TECHNICAL DATA SHEET

Date NO. 63

Issued by Engineering Division,
M.I. (Australia) Ltd.,
2 Parramatta Rd.,
Homebush...N.S.W.

MODEL L1

Modified Circuit (Additions shown dotted)

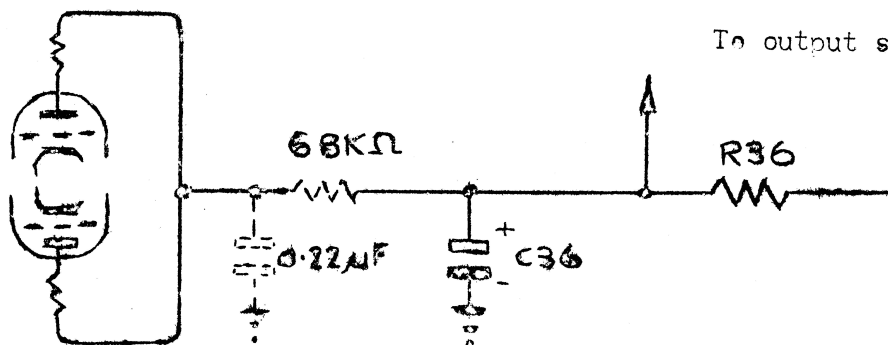
A circuit change has been made in the above model to reduce hum.

The change commenced with S/N02698 and consists of adding a filter section to the anodes of V4 as shown in the circuit below:

Components added are:-

740-0562 resistor, $68K\Omega \pm 20\% \frac{1}{2}W$.

279-1781 condenser, $0.22 \mu F \pm 20\% 400 V.W$.
